**Visions In Education**  
**TENANT IMPROVEMENT PROJECT**  
**Project # 26-01**  
**ADDENDUM NO. 2**

February 24, 2026

2.3 REPLACE the following sheets:

**M2.2**

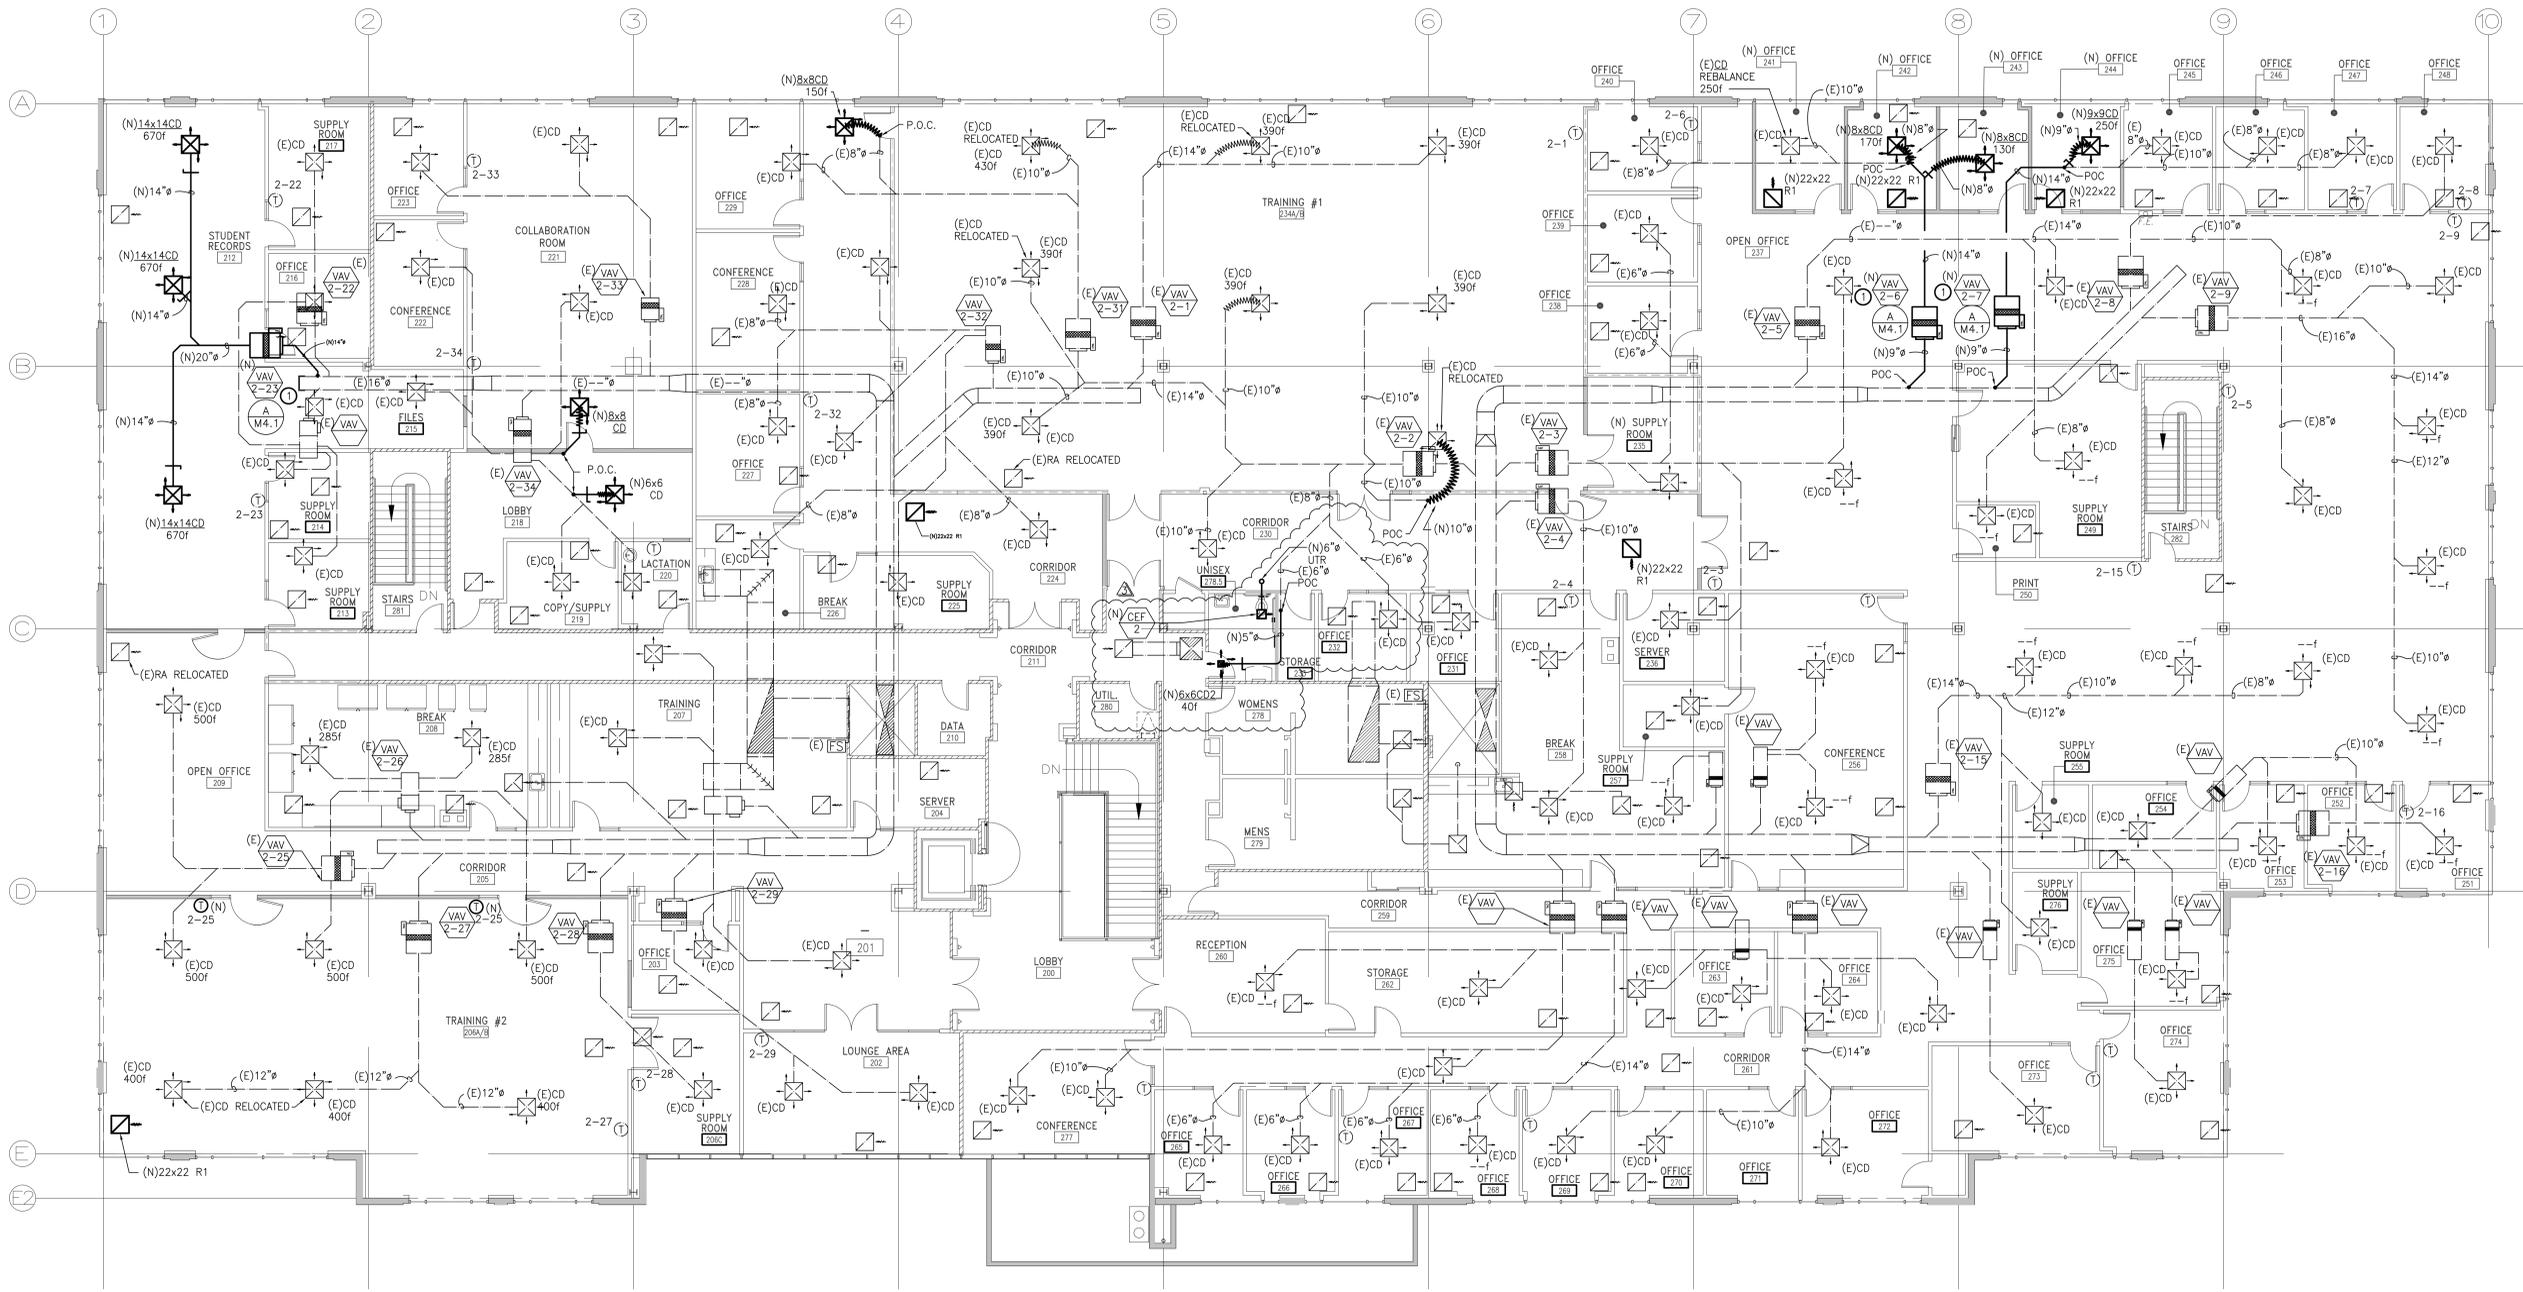
**QUESTION #17:** On page A2.8 it notes all T-bar is existing and only one spot where it notes some repair work is needed. On M2.2 there are new ducts and equipment required in multiple rooms. Can a demo page be provided for the T-bar showing the extent of how much T-bar is needed to be demoed for the new ductwork?

**QUESTION #26:** On M1.2 on the upper right side it shows demo of the area. Then on M2.2 it shows new offices and HVAC that is not shown on the architectural sheets. Are these offices already there? Is this HVAC already there?

**Response:** The mechanical duct work is identified and it is up to the contractors “means and methods” of working with the existing T-Bar ceiling system. See attached SD 2.1 /Addendum #2 for T-Bar coordination.

**Response:** A/M1.2 is an existing demolition plan and existing offices match 1/A2.1.A/ M2.2 new offices shown matches 2/A2.1 offices.

**2ND FLOOR PLAN - POWER & SIGNAL**

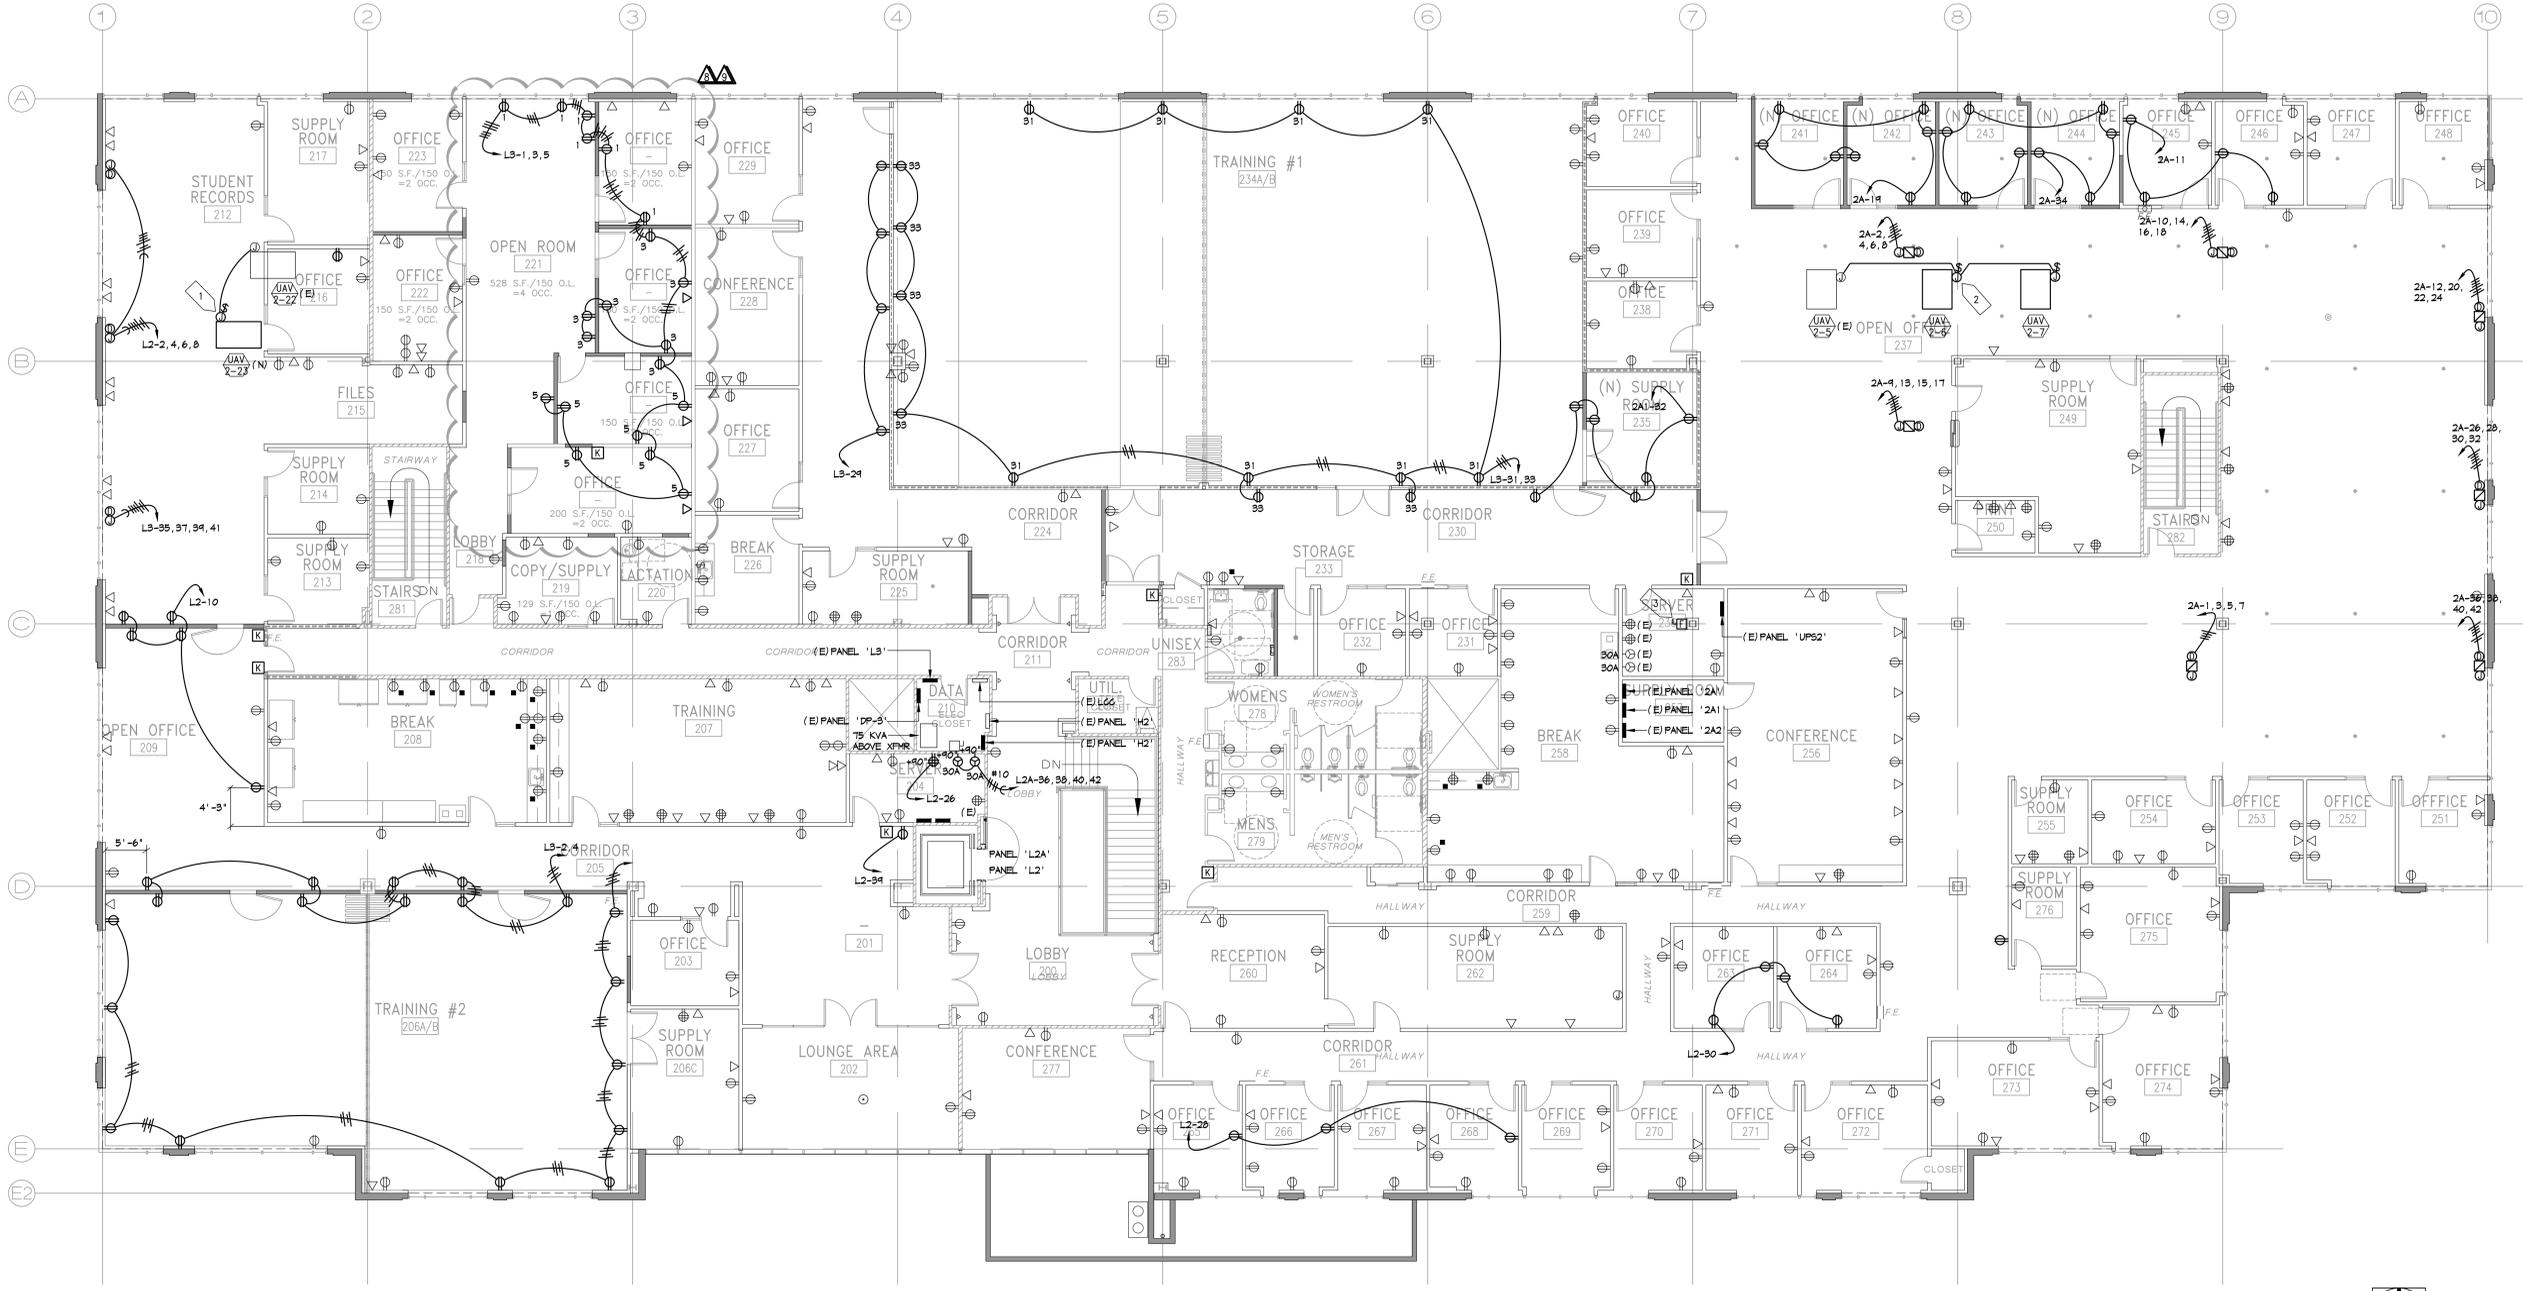
**QUESTION #18:** On E3.2 key note 9 - Refers to sheets E2.1B for exact control quantities and types. That page is not included in the bid set.

**QUESTION #20:** Page E3.2 shows a lot of new outlets throughout the space. Are we able to use cut in boxes for all of this or will EMT be required for all in wall conduits?

**Response:** Reference is to sheet E2.2A, delete keynote 9.

**Response:** Cut Boxes can be used.
